V2500 Propulsion System — Nacelle

Subject: Transmittal of Revision 1 to Service Bulletin Number V2500-NAC-78-0103

**NACELLE — EXHAUST — BOLT, PRESSURE RELIEF DOOR LANYARD —  
REPLACEMENT OF**

**V2500-NAC-78-0103**

PRESSURE RELIEF DOOR LANYARD BOLT REPLACEMENT  
FIGURE 1

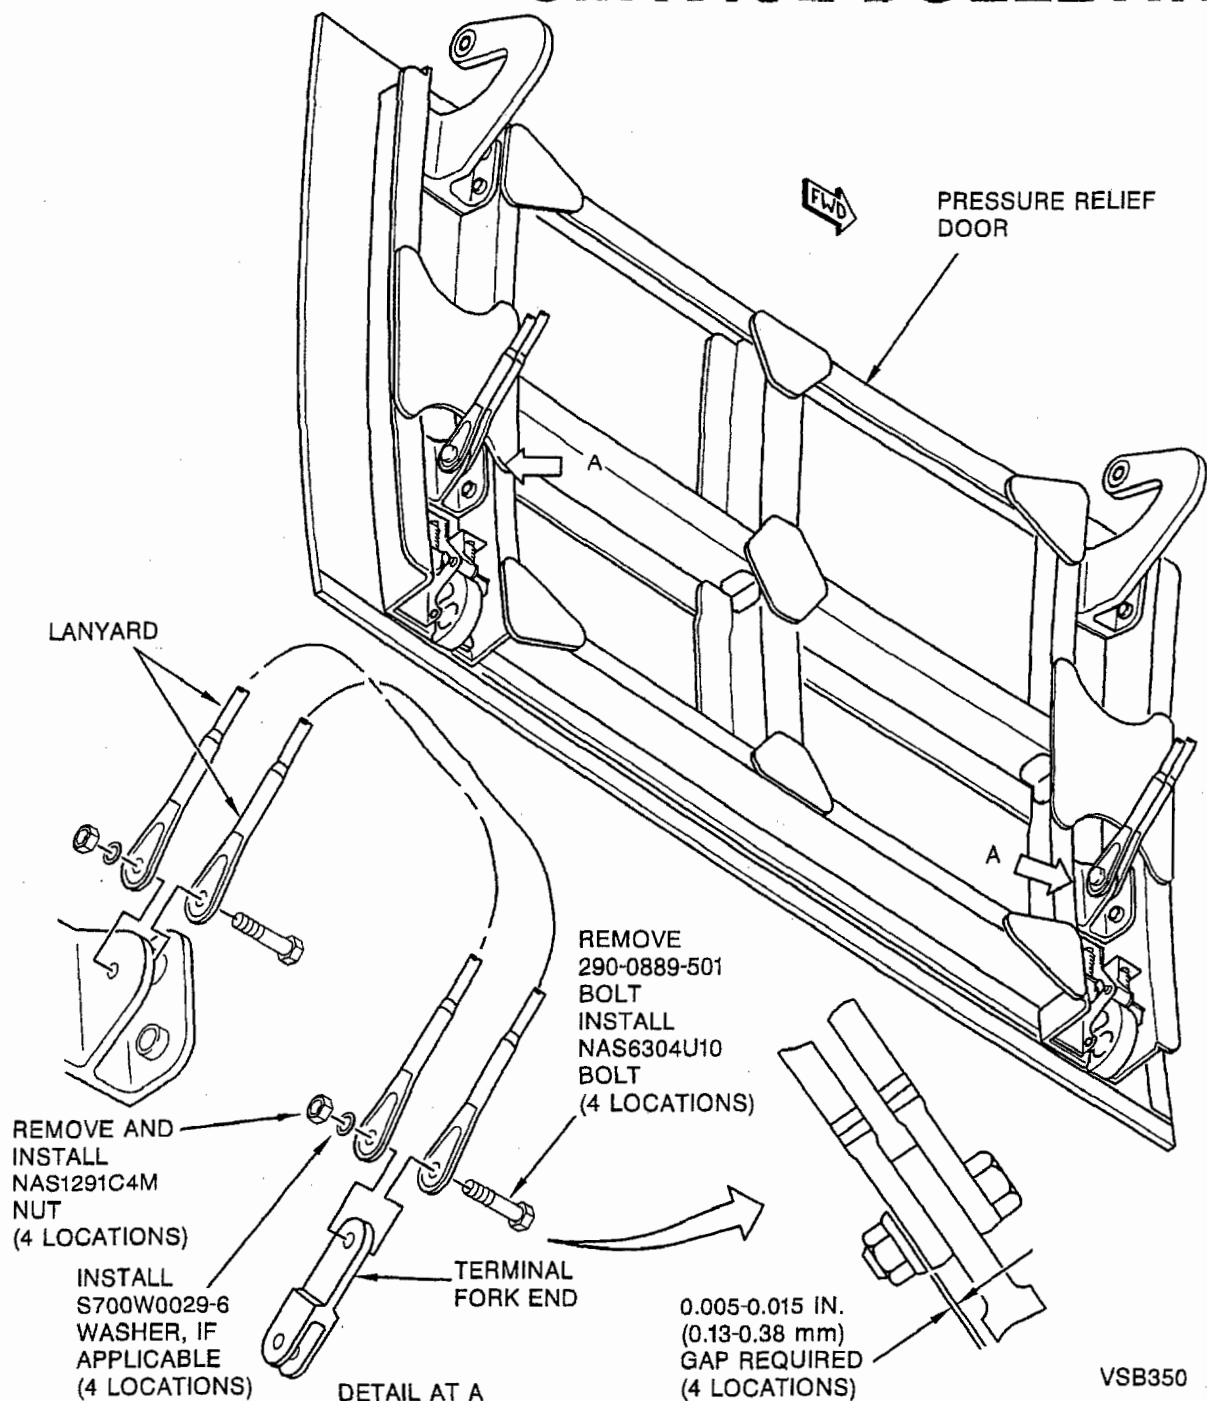
Due to possible clamp up condition of lanyard, it may be difficult to fully open pressure relief door.

Insufficient grip length of bolt.

The change introduced by this Bulletin is to replace the existing bolt with a longer grip standard bolt and add a laminated washer.

- (1) Remove four NAS1291C4M nuts and four 290-0889-501 bolts from four lanyards and two terminal fork ends on pressure relief door. Refer to Figure 1. Discard bolts. Keep nuts.
- (2) Install four NAS6304U10 bolts and four NAS1291C4M nuts on four lanyards and two terminal fork ends on thrust reverser pressure relief door. Torque nut to 10-20 lbf-in (1.1-2.4 Nm).
- (3) Measure gaps between nuts and lanyards. Gap should be 0.005-0.015 in (0.13-0.38 mm).
- (4) If any gaps are greater than 0.015 inch (0.38 mm), remove applicable NAS1291C4M nut. Install necessary thickness of S700W0029-6 laminated washer on NAS6304U10 bolt to obtain proper gap. Install NAS1291C4M nut and tighten to a torque of 10-20 lbf-in (1.1-2.4 Nm).
